Cobblestone Homeowners Association

ACC Meeting Minutes

29CR, Lopez, New Home - Kim Acorn reviewed the updated submittal for the Lopez new home project. Kim reviewed all the comments from the Lopez Architect in response to our requests. Please see attached for all questions and answers.

Re: Final submittal for Lot 29CR, 3120 E Crest Shadow Drive
Lopez Residence

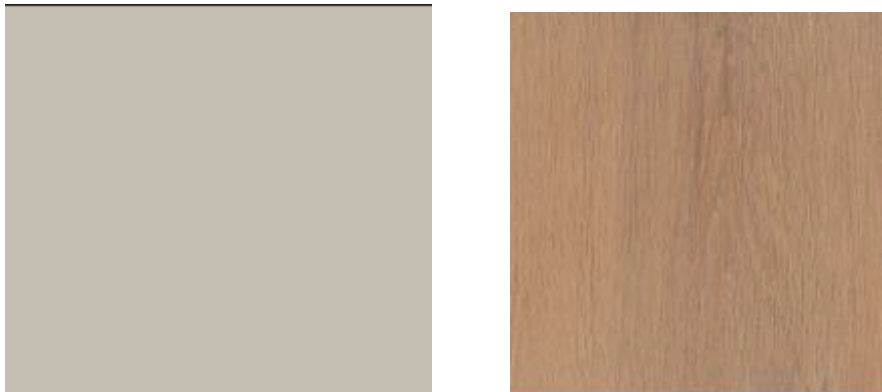
5.F. Clarify the construction of the guardrail. Letter says metal and cable, but detail says W.I. and steel tubes.

The railing will be per the detail shown on sheet 8.1. The letter was incorrect.
